PACKARD MOTOR CAR COMPANY

VOL. 28, NO. 10

OCTOBER, 1954

Direct Drive Clutch Slippage

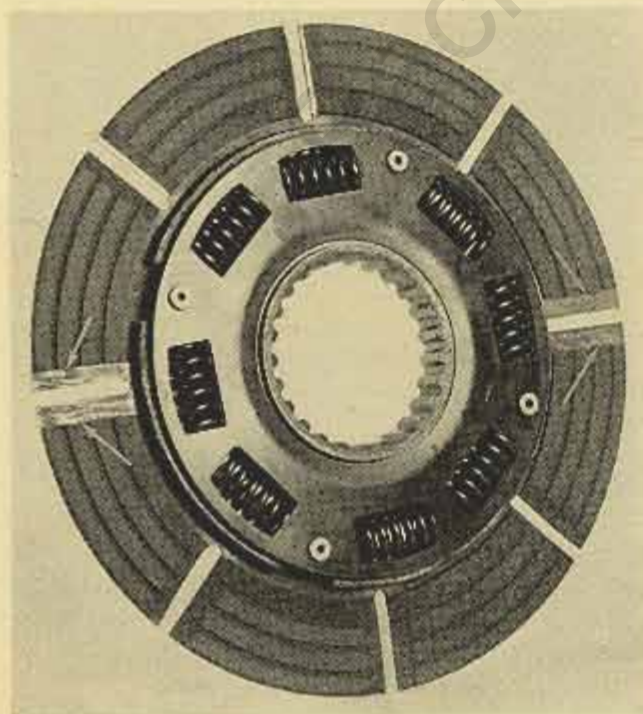
Direct drive clutch slippage may be encountered occasionally on early production Gear-Start Ultramatic Transmissions.

The ends of the clutch facings are chamfered at the slots in the driven plate to retain an oil cushion between the plate, pressure plate and the clutch piston, however, in some instances, this oil cushion has caused the clutch to slip.

If direct drive clutch slippage is encountered on early production units and the converter "in" and direct drive clutch pressures are within specifications, it is suggested that the direct drive clutch plate be removed and reworked as follows:

Using a razor blade, cut the chamfer portion off the ends of four facings at two slots on the rear side of the plate directly opposite each other as shown in the illustration. Be sure to leave a sharp square edge on the facings.

Cut off the chamfered ends of four facings at two slots directly opposite each other on the forward side of the plate.

When the direct drive clutch is engaging, the sharp ends of the facings will wipe the oil film from the pressure plate and piston thereby reducing clutch slippage.

Folding Top Header Water Leaks

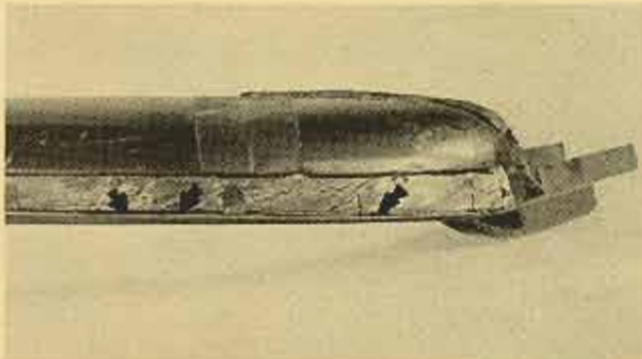
A few reports have been received of water leaks at the folding top side rails. These cases of leaks have been in the minority but in most instances, the source has been very difficult to locate.

If water should drip out of the forward ends of the side rails where they are bolted to the header, its

source may be traced to an opening at the forward lower edge of the header. "See arrows on the illustration." Water entering the header will flow back through the ends of the header and into the side rails.

Openings in the leading edge of the header can be sealed with Dolphinite Non-Drying Sealer by following the procedure outlined:

1. Remove the header trim mouldings and moulding retainers. Remove the tacks that attach the top covering to the header and remove the header trim welt. Do not remove the header weatherstrip unless it is necessary to reinsert it in place.

2. Carefully, work some sealer into any openings found along the leading edge of the header where the upper and lower panels are spot welded. Fill in the lower edge and ends of the tacking strip with sealer.

3. With the top lifted slightly from the windshield, tack the trim welt in place so that the welt bead will bear downward against the weatherstrip. Tack the top covering in place. Install the trim moulding retainers in place so that the trim mouldings when installed, will bear downward against the welt bead.
